Arborist Site Inspection Impact Assessment

Client:	Kosciuszko Thredbo, Euan Diver
Date of inspection	28/01/25
Address	Village Green, Friday Drive THREDBO NSW
Arborist completing inspection:	Andrew Downing, Senior Arborist Assess Trees at AQF 5, QTRA Licenced User

A request from Euan Diver was received to inspect six trees located on the edge of the village green and inside the children's playground area for the impact to tree health from proposed storm water trenching work, fence relocation work and paving and log slalom course construction.

Typical TPZ and 10% encroachment detail

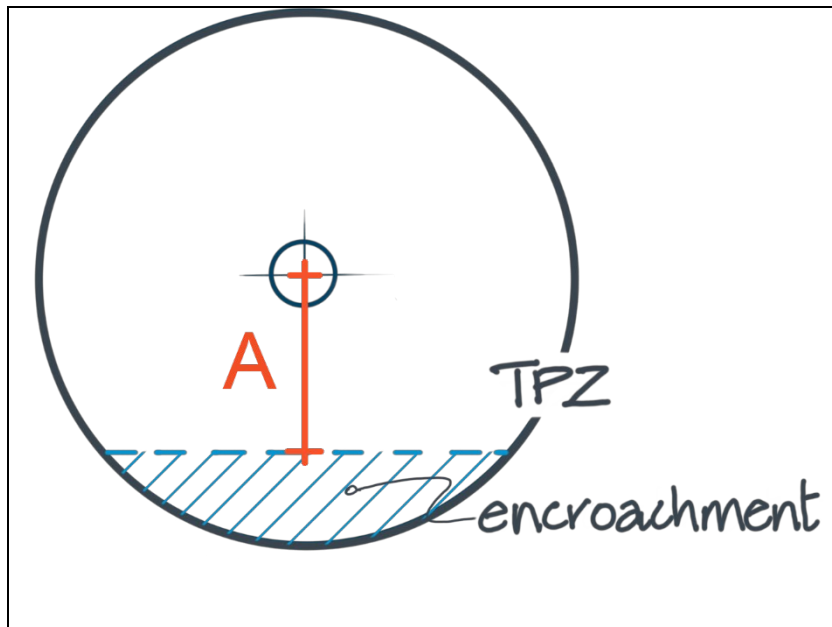
Any encroachment by mechanical trenching into the Tree Protection Zone (TPZ) that will cause damage to tree roots will have a negative impact on tree health and should be avoided. While a ten percent encroachment is permissible anything above this should be avoided. Any encroachment over thirty percent can cause partial decline or whole tree death.

The proposed line of excavation through the TPZ of trees one and two exceeds the permissible encroachment allowance of 10 percent.

A solution to this should include planning for minimal impact excavation techniques such as Hydraulic Vacscavation using high pressure water to cut through soil and vacuum suction to remove liquid debris or careful hand excavation. Any tree roots encountered must be avoided and left undamaged. Minor roots less than 20mm diameter may be cleanly cut using loppers or a hand saw.

The proposed Log Slalom course must be redesigned so the line of encroachment does not come closer than 6.6m from the centre of the main trunk to minimise the encroachment area to 10% or less. The footing detail for the logs should be bored footings which will aid in avoiding continuous disturbance within the TPZ and limiting damage to sub soil roots.
